VIRGINIA ELECTRIC AND POWER COMPANY
RICHMOND, VIRGINIA 23261

Serial No. 253
LQA/RMN:esh
Docket Nos. 50-280
50-281
License Nos. DPR-32
DPR-37

AMENDMENT TO OPERATING LICENSE
SURRY POWER STATION UNIT NOS. 1 AND 2
PROPOSED TECHNICAL SPECIFICATION CHANGE NO. 71
ADDITIONAL INFORMATION

VIRGINIA ELECTRIC AND POWER COMPANY
 ORGANIZATION CHART
 POWER OPERATIONS

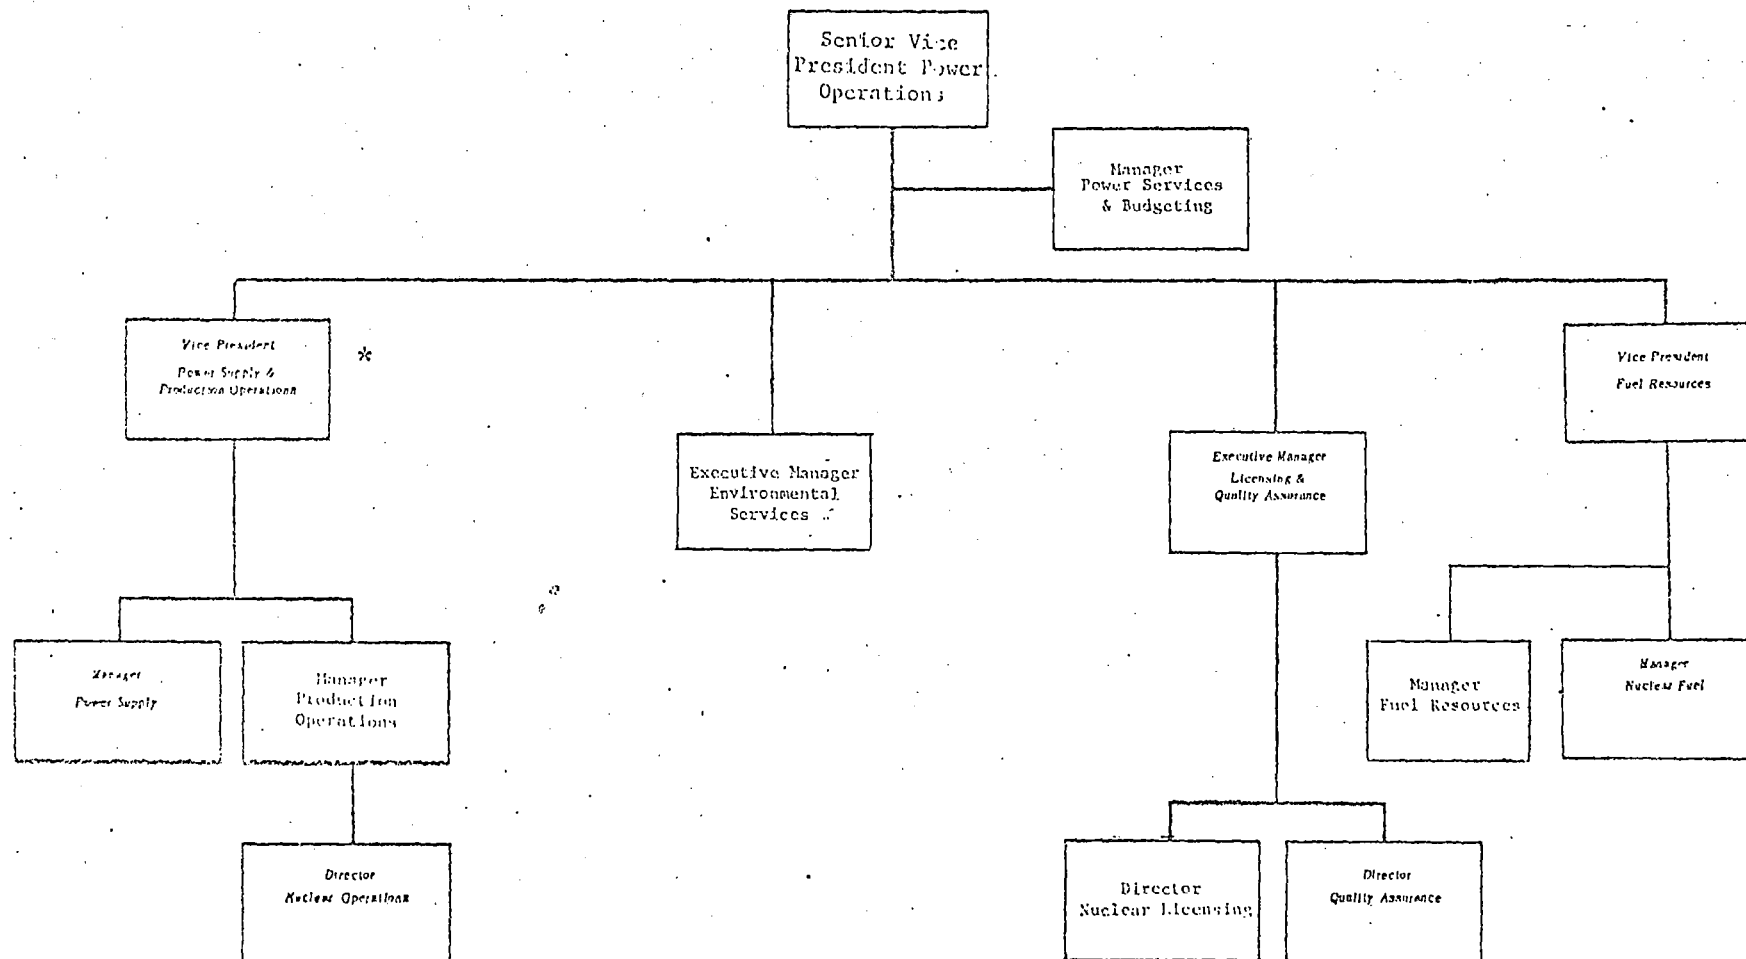
The August 31, 1978, submittal included a revised Figure 6.1-1, the Power organizational chart. There has been a management reorganization since then which is reflected in the attached revised Figure 6.1-1. The reorganization is designed to increase efficiency and therefore enhance safety.
